MCPB Item No. 9

Date: 12/4/14

Preliminary Plan No. 120140200, Northwood Knolls

Image 3 – Preliminary Plan

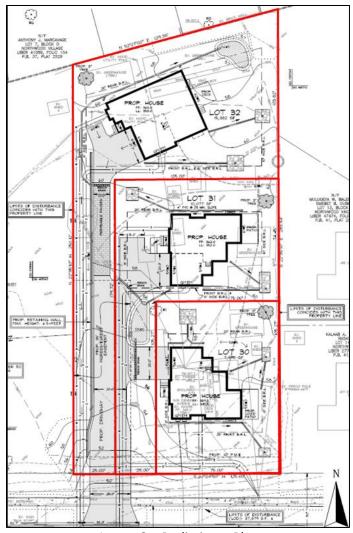
- 1) This Preliminary Plan is limited to three lots for three one-family detached dwelling units.
- 2) The Applicant must replace the existing 4-foot wide sidewalks with 5-foot-wide sidewalks with a green panel and street trees along the property frontage of Dennis Avenue, extend this reconstructed sidewalk off-site to the existing cul-de-sacs to the east and west of the property line, and provide a pedestrian connection to the existing bus stops, as shown on the Preliminary Plan.

Dennis Avenue is a 60-foot wide Primary Residential Street, P-7, with Class III or PB-10, signed shared roadway bikeway as recommended in the 1996 Approved and Adopted *Four Corners Master Plan*. Additional dedication of right-of-way is not required. Per the County Road Code, sidewalks are required for lots in the R-60 Zone. The Applicant is required to replace the existing 4-foot wide sidewalks with 5-foot wide sidewalks with a green panel and street trees along the property frontage of Dennis Avenue. In addition, the Applicant is required to extend this reconstructed sidewalk off-site to the existing cul-desacs to the east and west of the property line and to provide a sidewalk connection to the existing bus stops, as shown on the Preliminary Plan.
